LD&T MINUTES

DOCKET NO. 9-5-89 (Jefferson County)

Project Name: Micro Computer Solutions
Location: Eastpoint Parkway
Applicant: Tim Hollinden
Request: Detailed District Development Plan.
Proposed Development: To construct a three-story, 64,600 square feet office building.

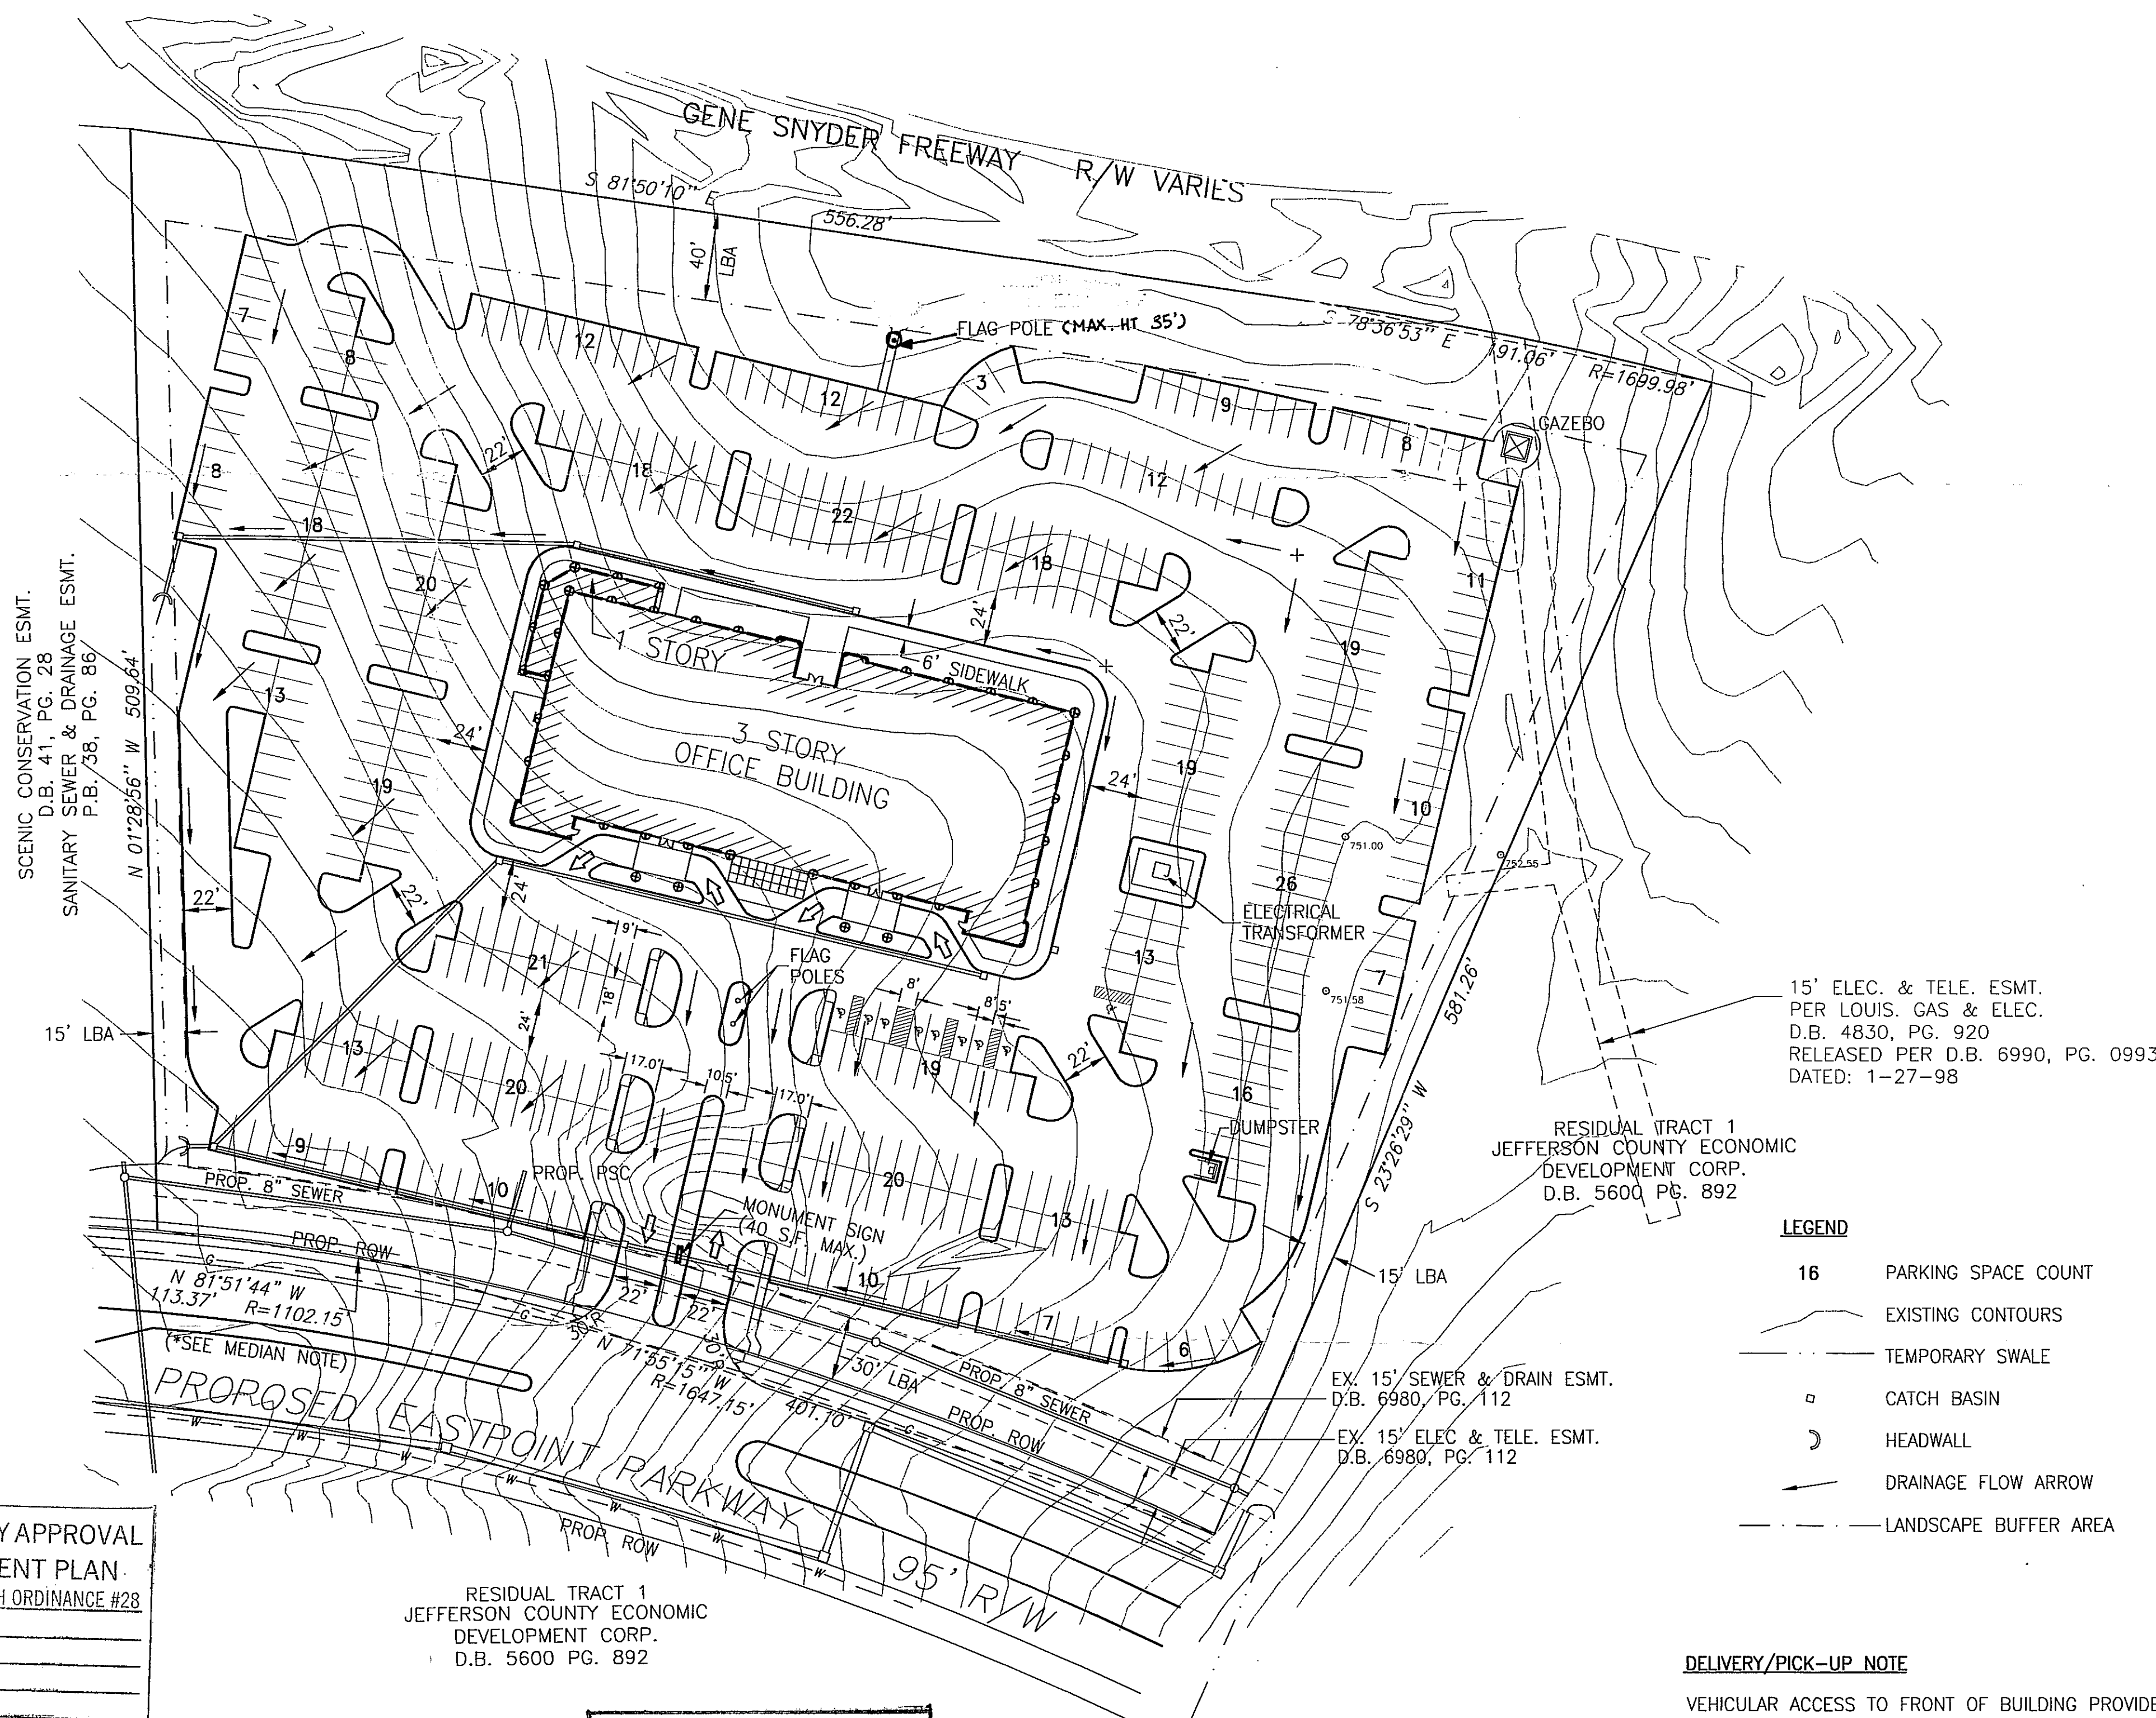
1. The structure will be approximately 45 feet in height.
2. There are two 80 square foot signs attached to the building. On the east side of the building and the other is on the west side of the building. These signs are in conformance with Jefferson County Fiscal Court Ordinance No. 7, series 1988, which allows attached signs that do not exceed 80 square feet within 200 feet of the Gene Snyder Freeway right of way.

3. A freestanding monument sign is proposed for this site. The sign is 40 square feet in area and six feet in height.
4. There are three flag poles located on this property. According to the Designated Parkway Guidelines flag poles on lots adjacent to a parkway cannot exceed 35 feet in height. Binding element number six limits the size of the flag poles to 35 feet.

5. In accordance with the Alternative Mode Transportation Guidelines, the plan shows sidewalks on Eastpoint Parkway. In addition, pedestrian connections are being provided from the building to the sidewalk on both sides of Entrance Drive.

6. The development is in conformance with the Development Code and the General District Development Plan.

1. The development shall be in accordance with the approved district development plan and agreed upon binding elements unless amended pursuant to the Zoning District Regulations. No further development shall occur without prior approval from the Planning Commission except for land uses permitted in the established zoning district.

2. There shall be no medical offices or other uses requiring a parking ratio greater than one space per 400 square feet of floor area unless parking can meet the requirement of the proposed use.

3. The development shall not exceed 102,700 square feet of gross floor area.
4. The only permitted freestanding signs shall be monument style signs, located as shown on the approved development plan. No portion of the sign, including the leading edge of the sign frame, shall be closer than 25 feet to front property line. The signs shall not exceed 40 square feet in area per side and 6 feet in height. No sign shall have more than two sides.

5. No outdoor advertising signs (billboards), small free-standing (temporary) signs, pennants balloons, or banners shall be permitted on the site.
6. The three flagpoles shown on the development plan cannot exceed 35 feet in height.

7. There shall be no outdoor storage on the site.
8. Outdoor lighting shall be directed down and away from surrounding residential properties. Lighting fixtures shall have a 90 degree cutoff so that no light source is visible off-site. Lighting levels attributable to the fixtures located on the subject site shall not exceed two foot candles at the property line.
